15TH AVENUE CORRIDOR IMPROVEMENTS

PREPARED FOR TAURANGA CITY COUNCIL

23 July 2019

Executive Summary

Figure 4-1: Departure angle proposed in design

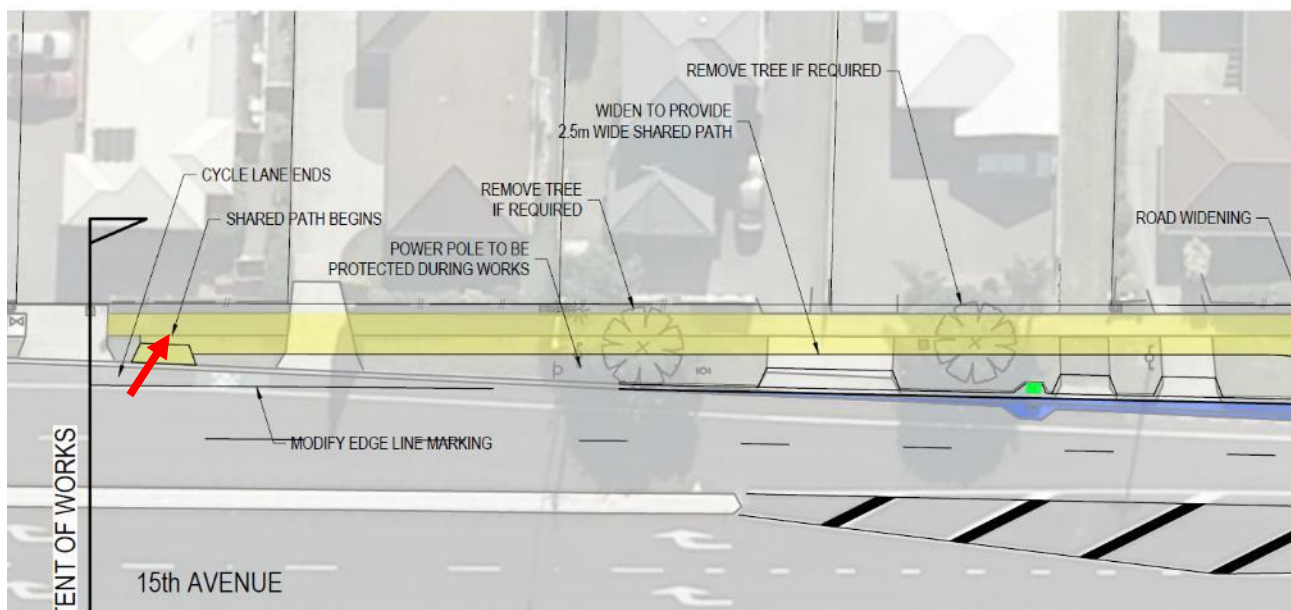
The proposed cycle crossing from the on-road cycle lane on to shared path (north side) is too direct and requires the cyclist to make too sharp a turn. The more acute the turn the less likely a cyclist will be inclined to use the shared path as intended. The drawings show a high angle of departure for cyclists traversing from the on-road facility to the off-road facility, as shown in Figure 4-1 below.

A high angle departure associated with a low nib at the back of the channel (typically 25mm at a cut down) can result in the wheels of bike being pushed sideways due to the angle of approach. This could result in a cyclist tipping into the adjacent traffic lane.

A safer more user-friendly alternative will require a longer transition from on-road to shared path and appropriate channel modifications to reduce the risk of cycle wheels being caught in the crossing cut-down.

1. Realign cycle lane transition from road to shared path to a less acute angle. Provide a construction detail of how the transition kerb cut-down will minimise any potential risk of wheel trap hazard.
2. Redesign the crossing point to a shallower angle, with a full dished channel without the nib typical of a kerb cutdown.
1. Reconsider location of shared path meeting the existing cycle lane – move further east to minimise the need for extra, and narrow, cut down.

Frequency	Severity	Rating
Crashes are likely to be common	Death or serious injury is unlikely	The safety concern is moderate
Designer response	Note on drawing #11 describes a 3m wide crossing to shared path with no lip as per T440 noted in drawing CA-011. We consider the design suitable for cyclists to make a controlled manoeuvre onto the shared path at an appropriate speed.

Safety Engineer comment	Agree with designer response. 3m wide crossing with no lip is a high standard of facility no change required.
Client decision	Agree with designer response
Action taken	Width can be revised onsite if required, with approval from Engineer.

Figure 4-2: Proposed crossing point over 15th Avenue

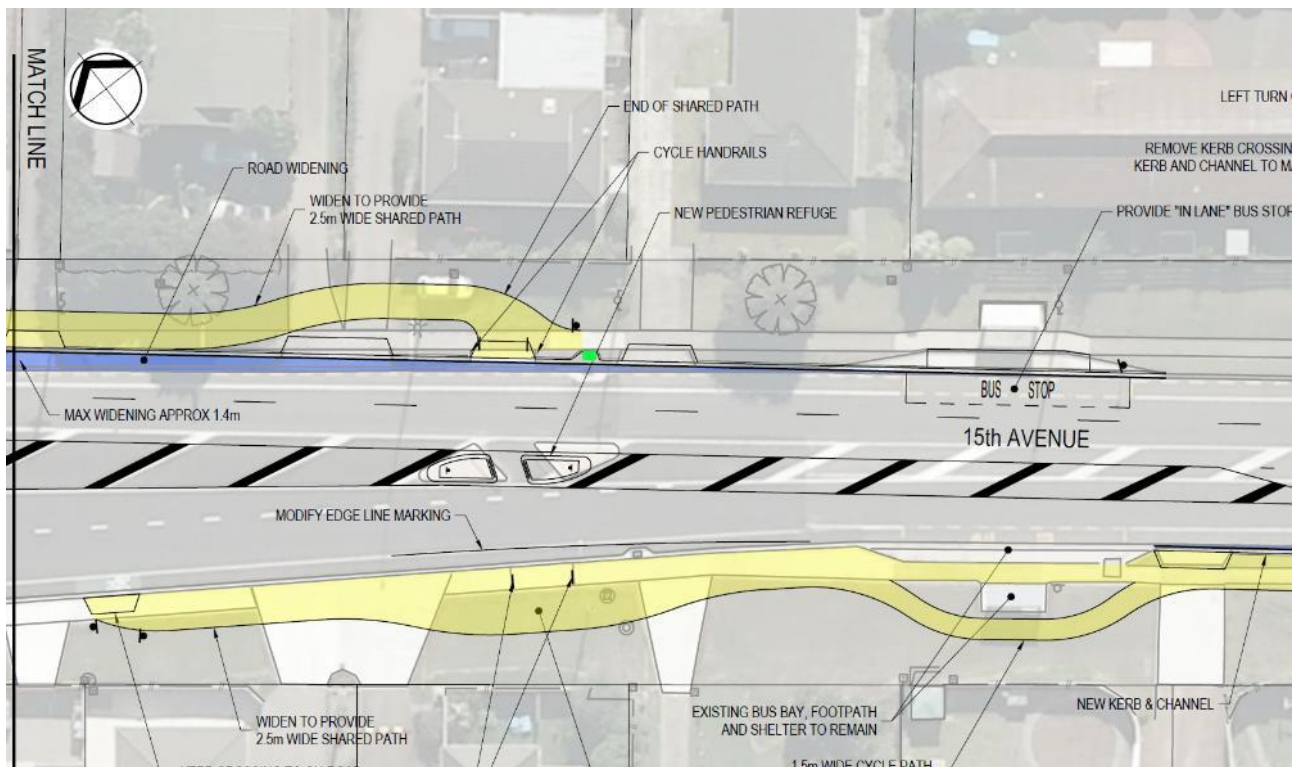
Where the proposed shared path meets the existing footpath at the proposed 3.6m wide kerb crossing point the current plans do not reflect the possible impact of the existing slope up to the existing boundary fence, the possible need for a retaining edge and the impact on the existing service pit levels in this area.

The design should reflect the actual desire paths of the various user types, and the path adjusted accordingly to reflect these, incorporating any adjustment that is required to maintain effective access to adjacent properties.

The plans indicate that the central pedestrian refuge is to be narrowed (both in length and in width) from that currently installed. The auditors are concerned that the new facility will have insufficient room for a parent with a pram to wait, at an angle that will allow them to view approaching traffic. This could also affect cyclists' available space. Both these situations could result in the user overhanging the edge of the facility, exposed to the oncoming traffic.

1. Review queuing space requirements for bikes waiting to cross 15th Ave at this new crossing point and the impact of bikes waiting to cross the road relative to the space required for pedestrians moving east along footpath.
2. Provide a detailed cross section through this crossing point to show that the proposed path can be constructed to the alignment as shown without additional retaining structures or requiring moving of light pole or services.
3. Review the width of the central pedestrian refuge to ensure that a user can safely wait mid crossing. Special consideration should be given to the use of the crossing by bi-directional cycle movement, parents with prams, and mobility scooter users.

Frequency Crashes are likely to be occasional	Severity Death or serious injury is likely	Rating The safety concern is moderate
Designer response	<p>Agree we can widen the shared path on the north side to provide more space for pedestrians walking around cyclists waiting to cross the road.</p> <p>We acknowledge the possible impact on service pit, this may need to be lowered slightly during construction to suit.</p> <p>We do not consider a retaining wall is likely to be necessary as the height difference is in the order of 300mm across 2m of ground.</p> <p>The refuge is per typical TCC detail at present. We agree widening the through passage so two cyclists can comfortably pass, e.g. 2.5 – 3m width, would be beneficial.</p> <p>We can amend the design in this area to suit.</p>	
Safety Engineer comment	Agree with designer's response. Recommend an increased taper to the end of the path on the northern side of 15 th Avenue to create more space behind the hold rails. Recommend increasing the separation of median refuge islands from 2.0m to 2.5m wide.

Figure 4-5: Grace Road (West) intersection. Proposed design.

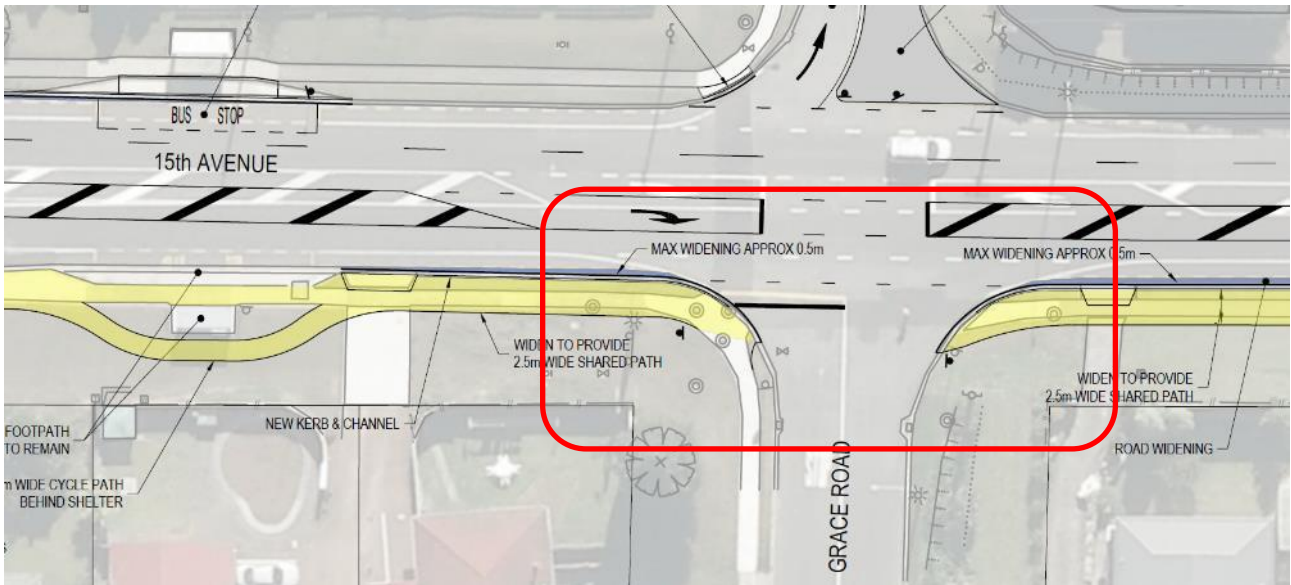
The proposal for the shared path extension on the corner of 15th Ave and Grace Road, south side, lacks detail around how the proposed shared path is to be constructed when considering the space around existing service covers, along with the alignment up and across the existing steep gradient.

In addition to this – it is best practice to have the crossing cut-down locations over Grace Road formed such that a visually impaired / mobility impaired user crosses the cut-down at as close to a 90-degree angle as possible. In this instance it may require the crossing point to be further down the side road, but final placement needs to be aware of the sight lines required at the crossing location.

2. Provide detailed sections from east to west side of Grace Road, south side, showing how levels, services and existing signage and light poles will be accommodated.
3. Ensure that the correct guidance is given for the visually and mobility impaired user.

Designer response	<p>The gradient of the path is not modified in this area. The design is also not changing the height of the manholes. One additional manhole will be in the new shared path.</p> <p>Additional survey would be required to prepare detailed cross sections. The design largely retains the current ground levels, underground services are not impacted, and above ground services are avoided so we consider there would be little benefit in producing detailed sections.</p> <p>The crossing angle appears to be an existing issue that is not modified by the design. TCC could consider reviewing the corner radii to tighten the entry to Grace if this improves the crossing alignment.</p>
Safety Engineer comment	<p>Agree with designer's response. The issues for visually impaired are not being made worse by the proposal and this not a high demand area for these users. Taking the path too far off the desire line for cyclists and other pedestrians may result in them not using the provided facility. Recommend Investigate tightening the kerb radii. Consider the provision of warning and directional tactile pavers.</p>

Client decision	<p>Agree to investigate tightening the kerb radii.</p>
Action taken	<p>BECA to revise design and come back to TCC for comment/approval. Hold point during forming of kerb to allow for site visit with Engineer and TCC Road Safety Engineer to determine kerb radius.</p>

Figure 4-8: Grace Road (east) Intersection. Proposed design.

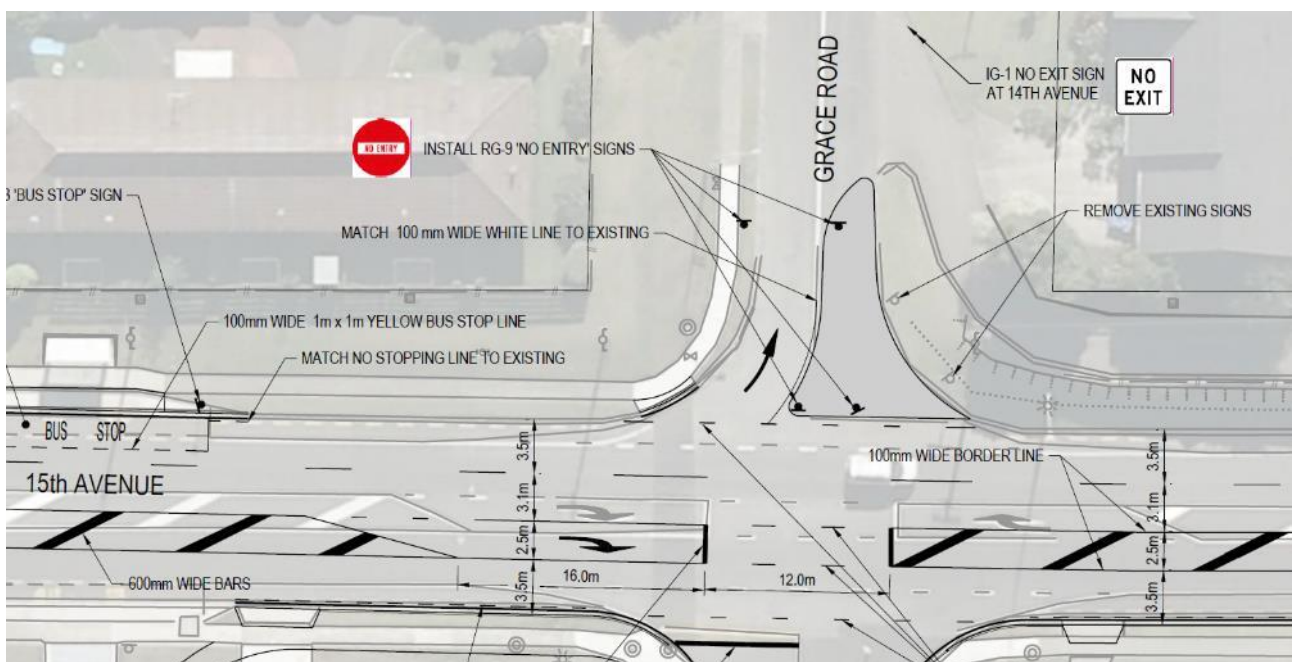
The audit team note that Grace Road, north side, is to be altered to a left turn in only from 15th Avenue. The team acknowledge that the proposed concrete island will form a lane closure preventing drivers from undertaking a left turn exit on to 15th Avenue.

It is noted that the island is up to 10M wide and 15M long and does not reflect the high amenity streetscape values (wide grassed berms and tree planting) of Grace Road, nor does it add any aesthetic or amenity value to 15th Avenue itself.

The team consider that the amenity value of the street could be enhanced with the provision of suitable planting or landscaping.

The auditors note that the intent of the design is also to prevent a right turn in movement from the northbound direction along 15th Avenue. The plans detail the inclusion of “No Entry” signs on the island. At peak times these signs will not be visible to the traffic in the opposing traffic lanes (northbound).

1. Replace proposed concrete with a combination of planting, trees, and grass.
2. Review the design to incorporate suitable restrictions for the right turn in movement, along with the crossing movement on Grace Road.

Frequency Crashes are likely to be occasional	Severity Death or serious injury is likely	Rating The safety concern is moderate
Designer response	TCC could consider planting or grass in the island however this could create a safety in design risk for maintenance contractors to be mindful of. Alternatively, a cobblestone or other treatment could be considered by TCC. Traffic counts indicate around 10 vehicles per hour turn right from 15 th Ave northbound to Grace Road in the peak periods, fewer cross from Grace road south. The design removes the right turn arrow, includes no right turn signage and no entry signs. Most significantly the design provides a protected right turn facility at the Burrows Street signalised intersection that will make it easier to enter the road network north of 15 th Ave and should mitigate the need to turn right at Grace Road.	
Safety Engineer comment	Accept designer's response. Monitor operation of intersection post construction and consider further signage if needed.

Client decision	Agree with response and staged approach to signage post construction	
Action taken	Monitor vehicle movements post construction.
